Product Change Notice (PCN)

Subject: Change in Marking Format on Humidity Sensor HS3000 series

Publication Date: 4/25/2024

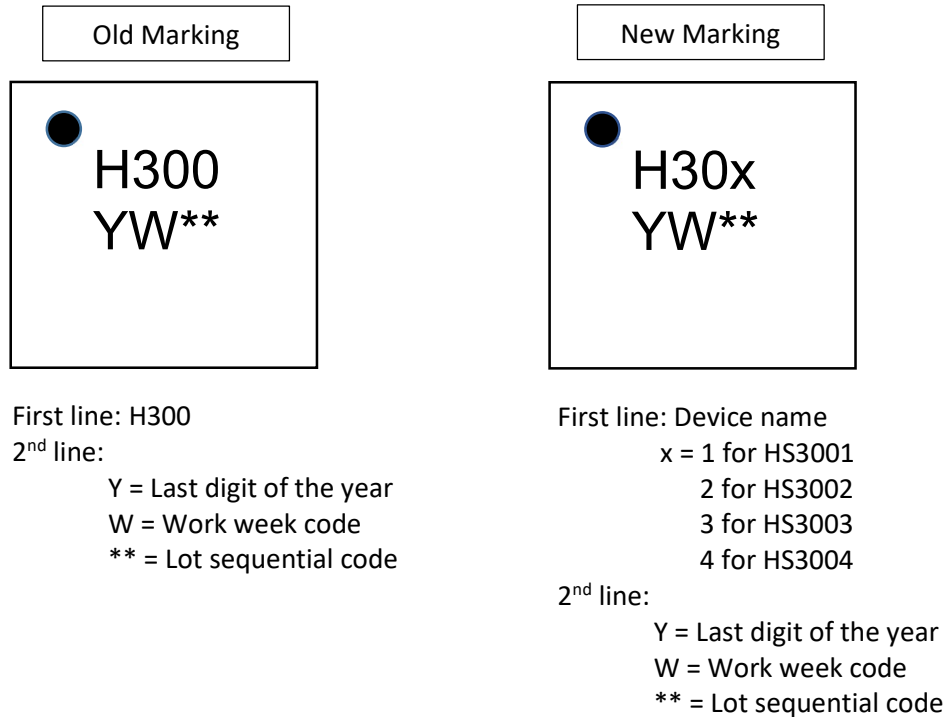
Renesas is changing the marking format on the first line as shown in the below diagram.

Marking on the first line.
